Aylesbury Estate Regeneration: Phasing Plan

Reasons for proposed changes

Summary of Changes

Masterplan

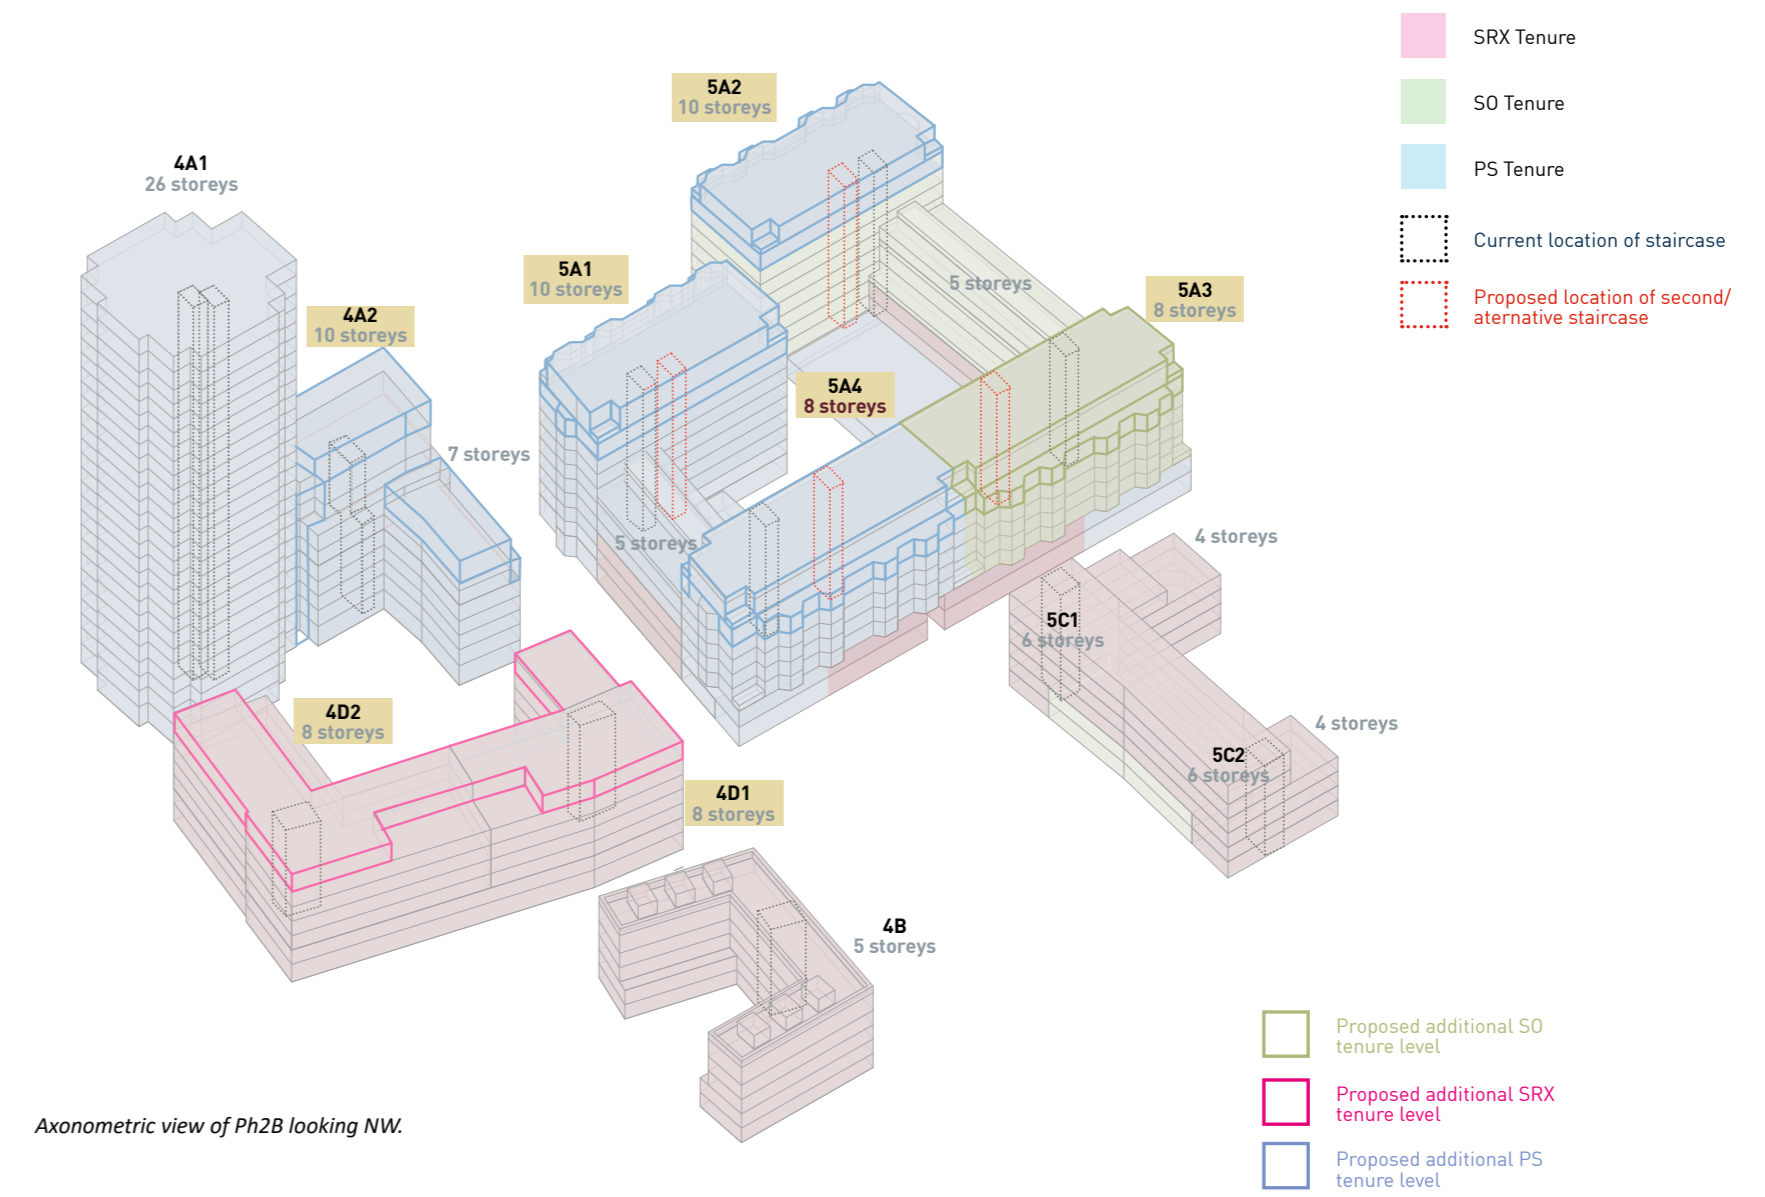
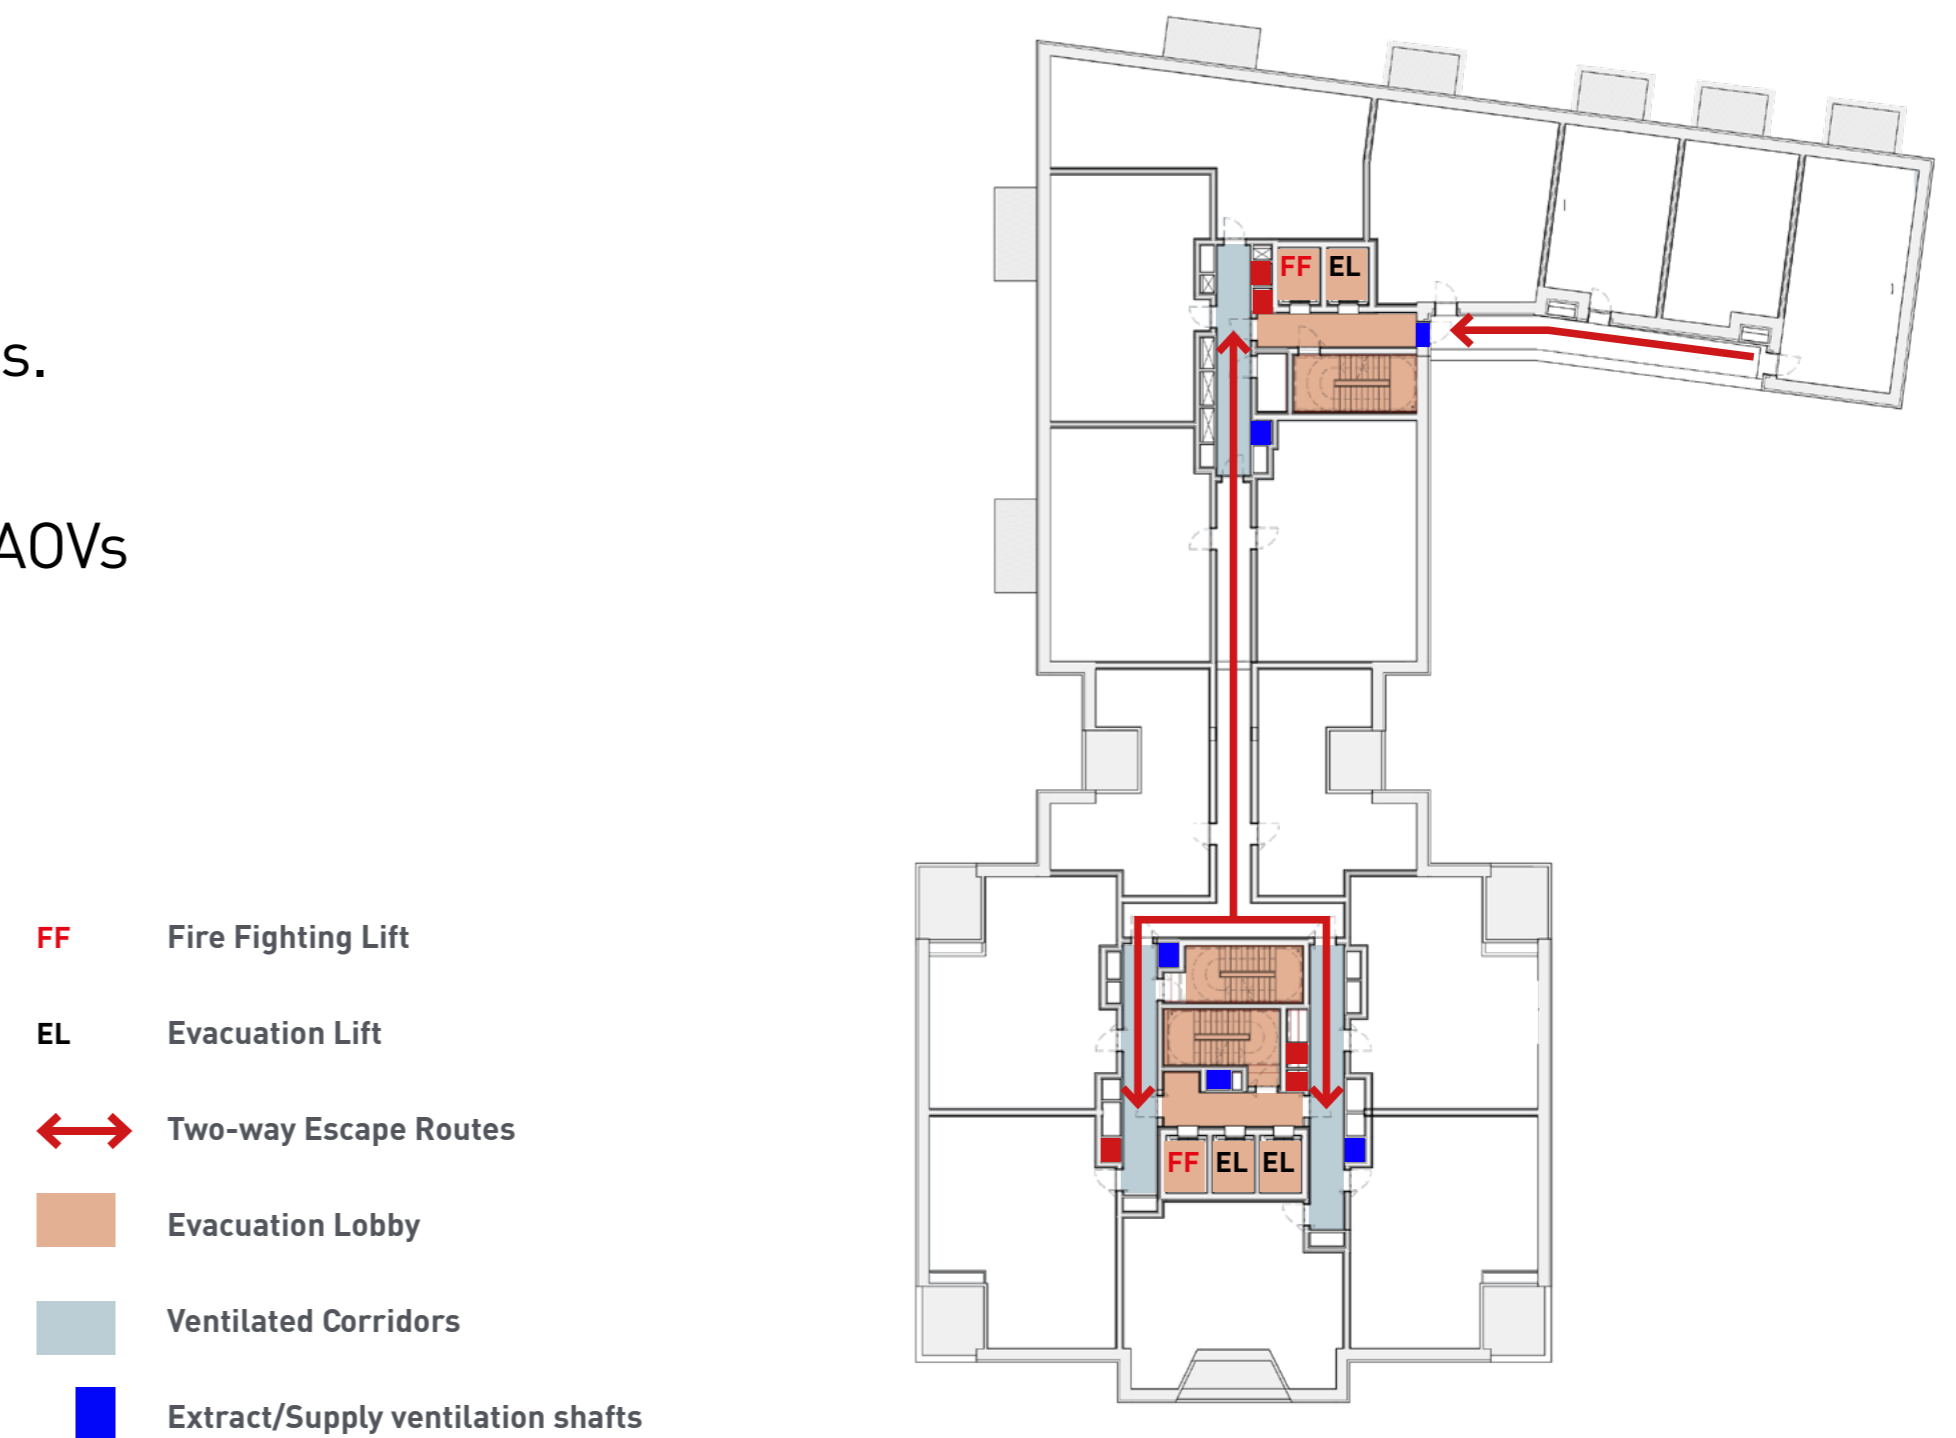
The overall design of the Phase 2B Masterplan is unchanged from the previous application scheme. Due to various updated requirements, there has been an impact internally within the buildings that has reduced the amount of floorspace available for housing space. To offset this, some of the buildings have increased proportionally in size, in order to provide additional floorspace for housing.

Plot 4A key changes:

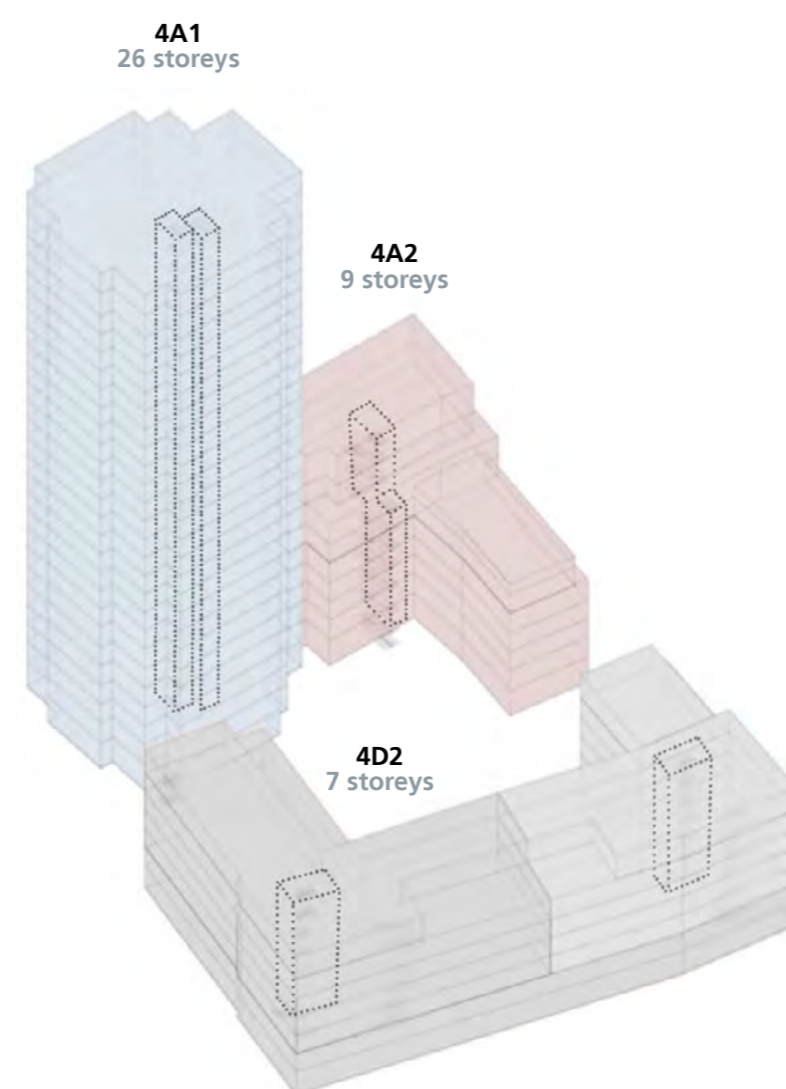
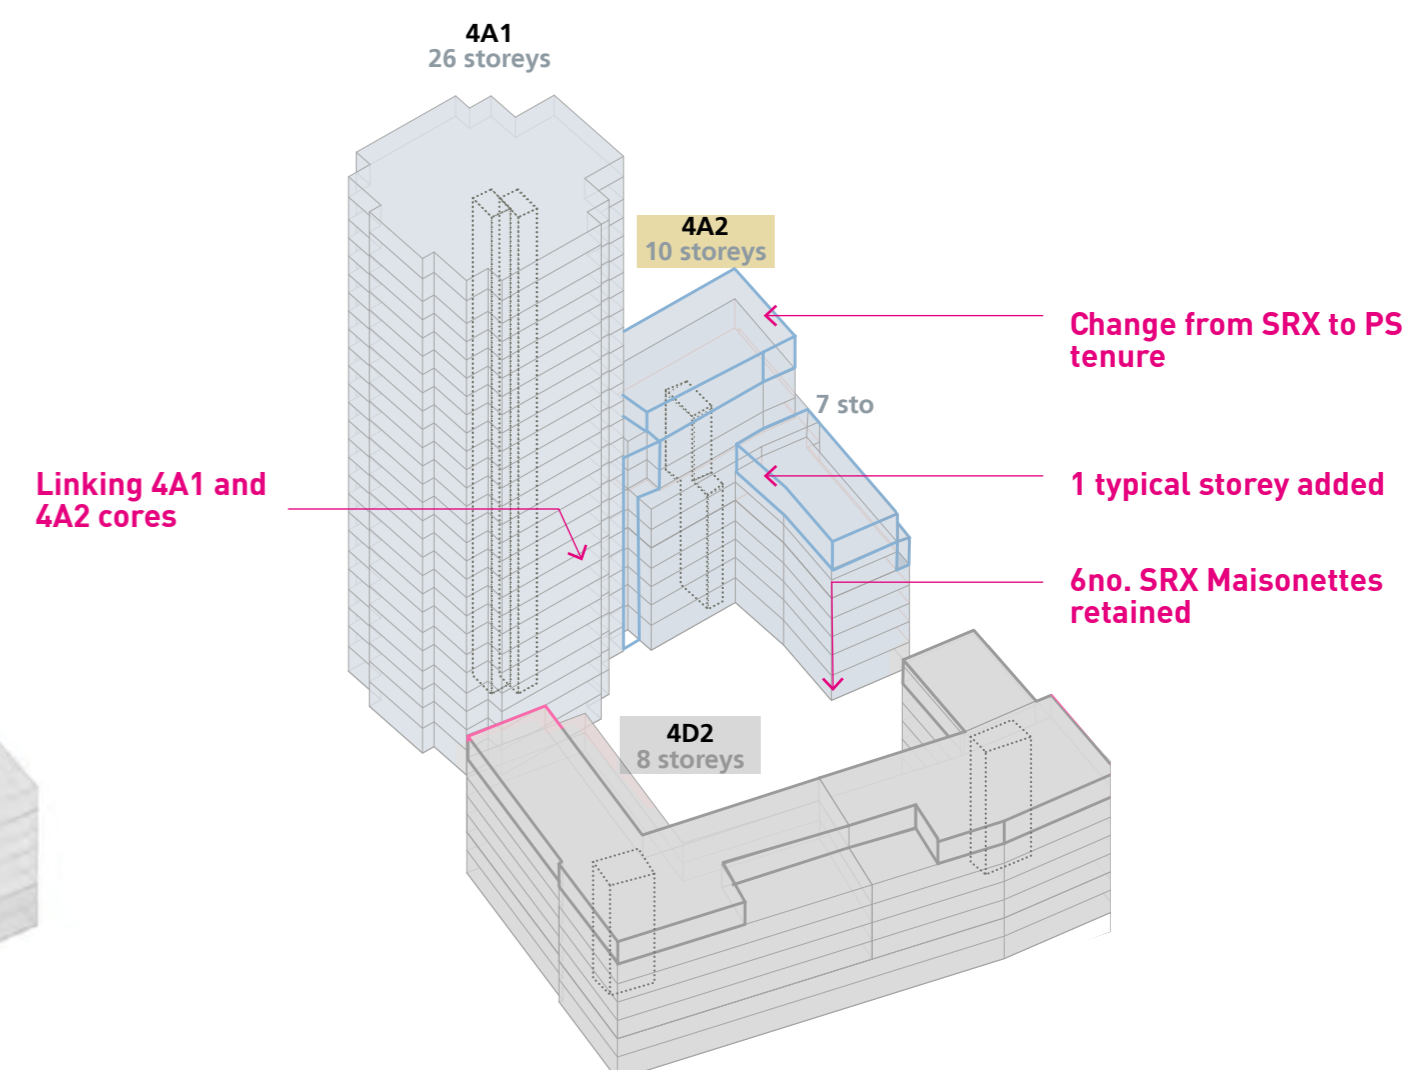
- Stay-put strategy with at least TWO escape stairs at each level.
- 4A1 and 4A2 cores have been linked, enhancing escape routes to all units.
- Risers have been removed from evacuation lobbies.
- Enhanced smoke ventilation system to protected lobbies, corridors and AOVs to the head of all stairs.
- One fire-fighting and one evacuation lift for each core.
- Maximum travel distance to a dead end is under 7.5m.

- Cores 4A1 and 4A2 linked with corridor to provide access to second stair case.
- Core 4A2 tenure changed from Social Rent to Private Sale (no maisonettes remain Social Rent).
- Additional storey of accommodation added to core 4A2.

Plot 4D key changes:

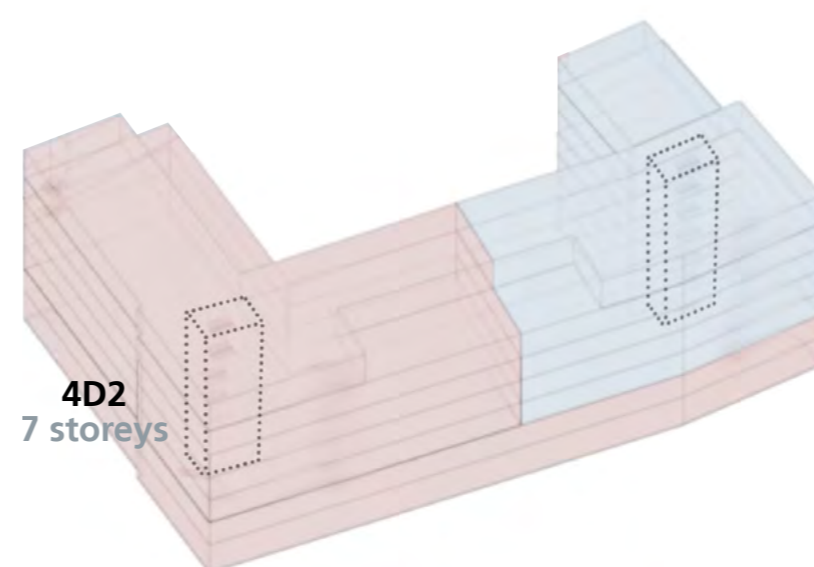
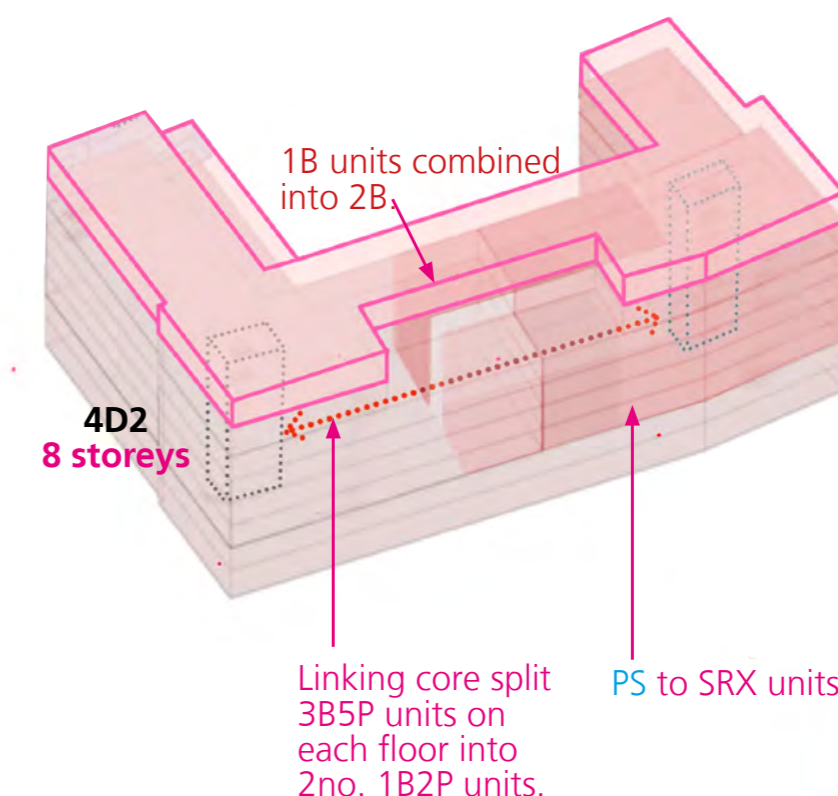
- 4D1 and 4D2 cores now connected by central corridor from Level 2 upwards, as required for fire escape.
- Third basement escape stair added to 4D1 core.

- Cores 4D1 and 4D2 linked with corridor to provide access to second stair case.
- Core 4D1 tenure changed from Private Sale to Social Rent.
- Additional storey of accommodation added to Cores 4D1 and 4D2.

Plot 5A key changes:

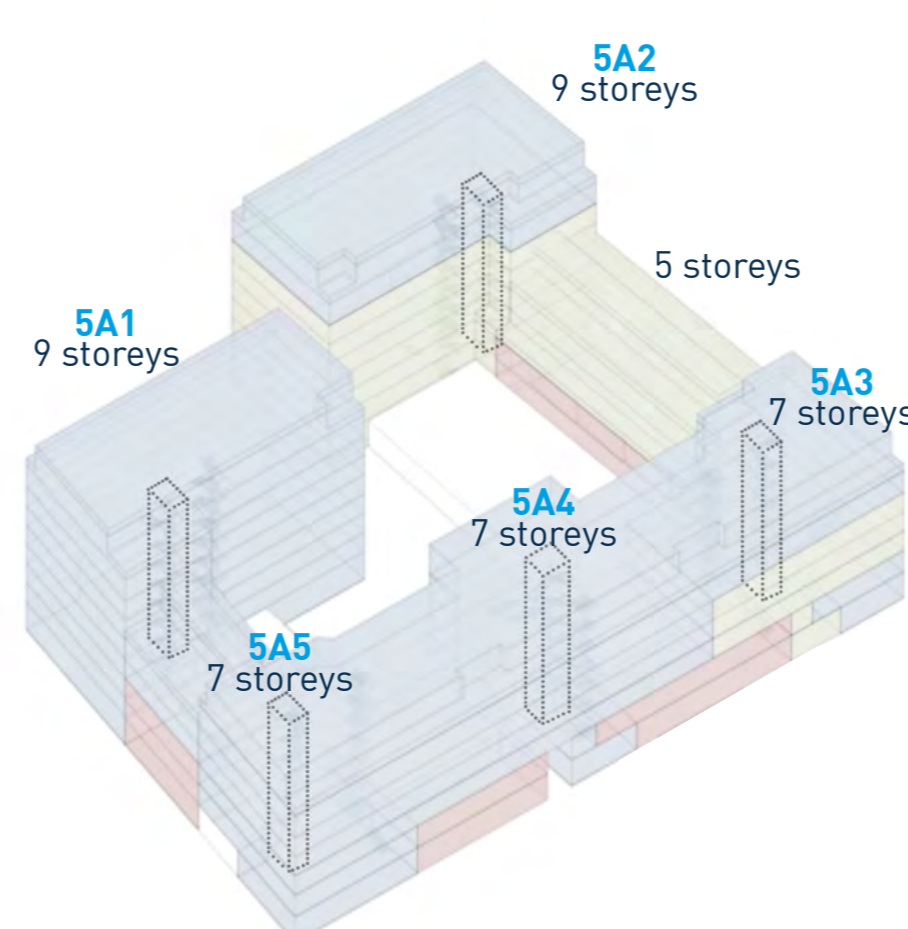
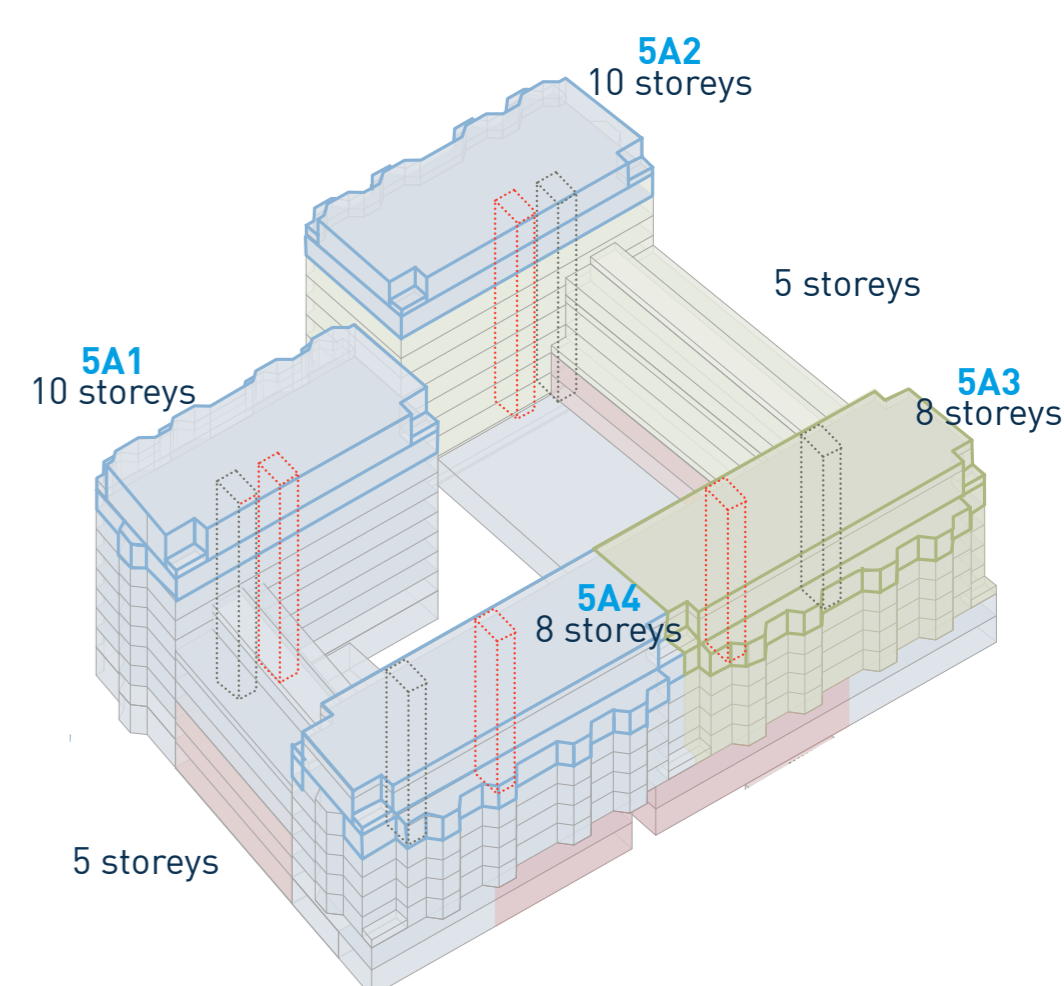
- Stay-put strategy providing two escape stairs from each apartment.
- Evacuation lobby with refuge space, protected stair and Evacuation Lifts within 7.5m away from all dead-end apartments.
- Deck access flats provided with escape into 2 different cores.
- Enhanced smoke ventilation system to all lobbies.

- 5 cores changed into 4. Each core now contains 2 staircases. In total additional 3 staircases added to 5A.
- Additional intermediate level to Blocks 5A1, 5A2, 5A3 & 5A4.
- Change to massing, where the 5-storey stacks of maisonettes meet the taller blocks. Additional stacks of 3 storey maisonettes - providing more street accessed accommodation.
- Increased back-to-back distance between 5A2/5A3 and 5A1/5A4.
- Change to the rhythm of bays on the mansion blocks.
- Improved entrances visibility to 5A1 and 5A2.
